To: T10 Technical Committee
From: Rob Elliott, HP (elliott@hp.com)
Date: 11 November 2005
Subject: 05-322r1 SAS-2 Wide port simultaneous connection rules

Figure 1 — Destination group example (perspective from initiator port)

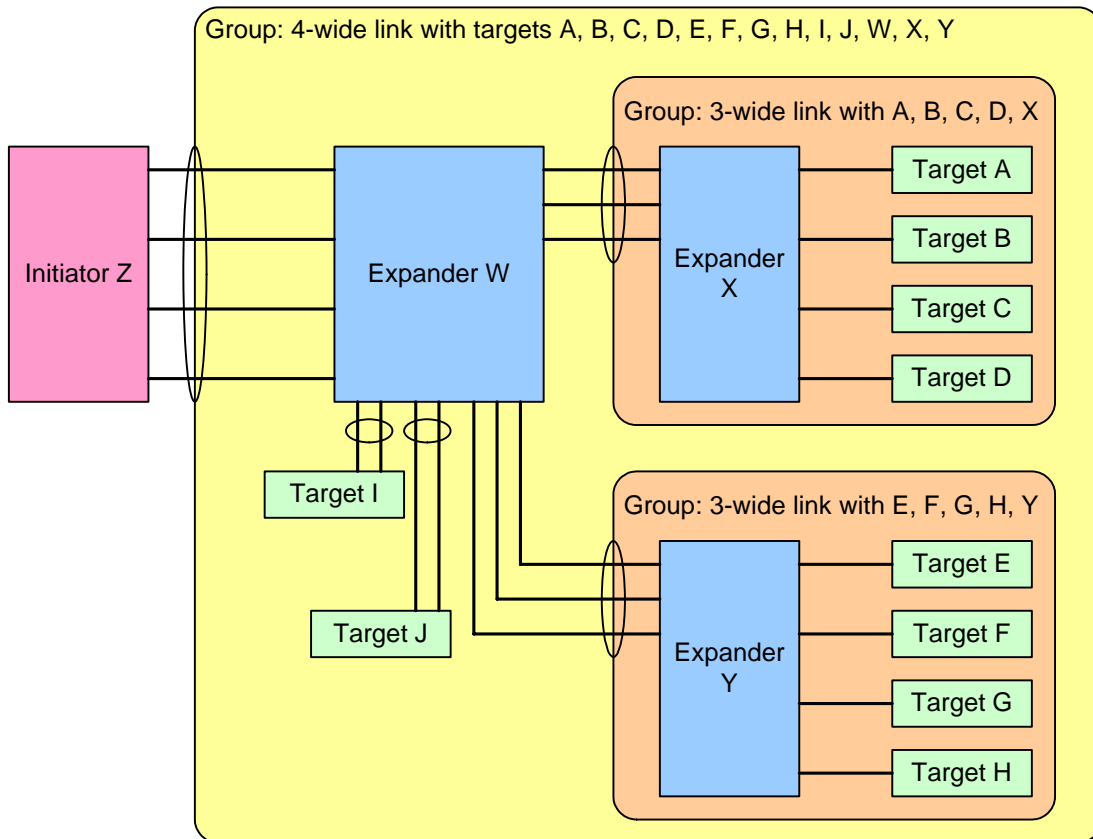
For example, in figure 1, the initiator port considers all the expander devices and target ports to be part of a destination group sharing the 4-wide link. A, B, C, D, and X are in a separate destination group sharing a 3-wide link. E, F, G, H, and Y are in another destination group sharing a 3-wide link. I and J are just in the main destination group (each could be considered part of its own 2-wide destination group as well, if that is a convenient way to keep track of destination port widths).

For example, if Z is connected to A, B, and C, it should not attempt a connection to D (because the 3-wide group to which it is a member is exhausted); instead, it should favor a connection to another destination that does not belong to a group that is exhausted.
